CLIENT PROJECT REPORT 1730

Parkhurst Road, Islington - PERS audit report

Project: Parkhurst Gardens, 65-69 Parkhurst Road, London
Client: Transport Planning Practice
Document: Stage 1 Road Safety Audit
RKS Associates Ref: VRP370-01
Issue date: 29th November 2013
Status: Final
Authorised by: VP/MB

Appendix A

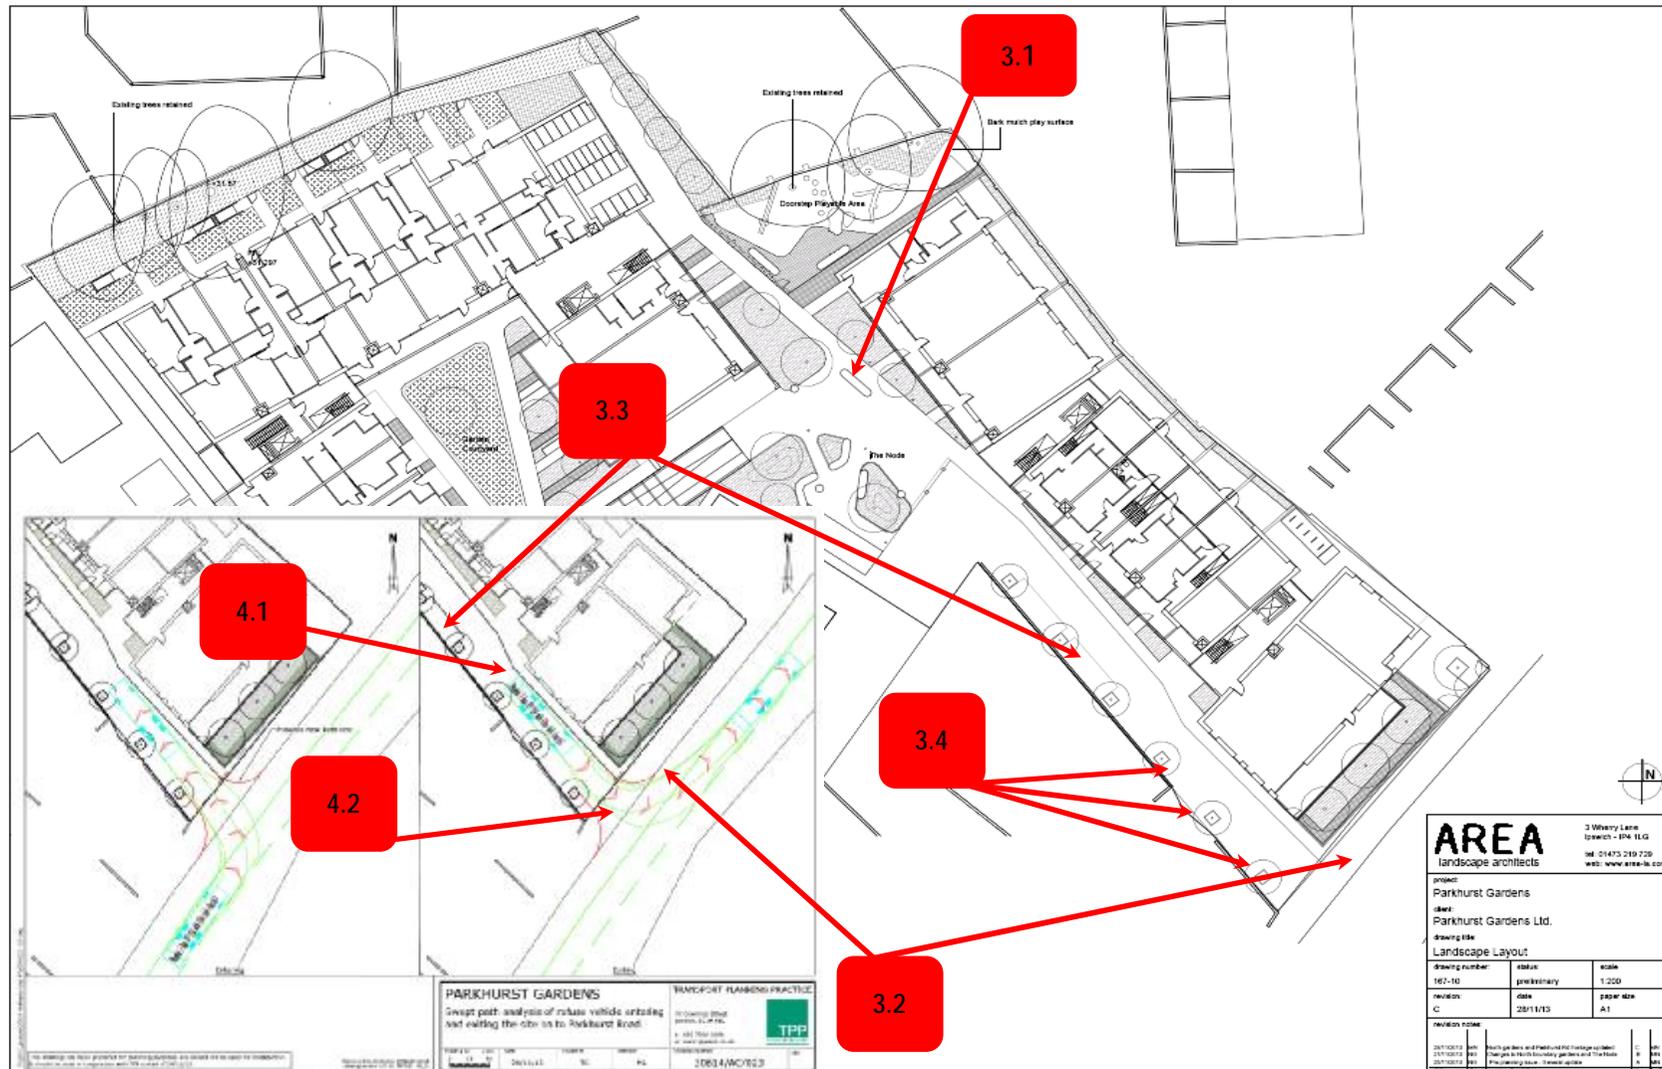
The landscape layout drawing indicates that trees are to be planted along the south western side of the access road; consequently motorists who are unfamiliar with the layout may collide into the trees. In addition, overtime the tree canopies may restrict access for high sided vehicles entering the site.

Ensure that any tree planting along the south western side of the access road does not restrict safe access for vehicles entering the site.

Provide dropped kerbs and tactile paving either side of the access, further measures to provide a contrasting surface treatment between the access road and pedestrian footpath should be provided.

3.4	Ensure that any tree planting along the south western side of the access road does not restrict safe access for vehicles entering the site.	The type of tree used is being reviewed in order to minimise the encroachment of the trees on the access route. The access with the highway has been tracked to ensure that two vehicles can pass.

4.2	Provide dropped kerbs and tactile paving either side of the access, further measures to provide a contrasting surface treatment between the access road and pedestrian footpath should be provided	Accepted, can be incorporated in the detailed design stage.
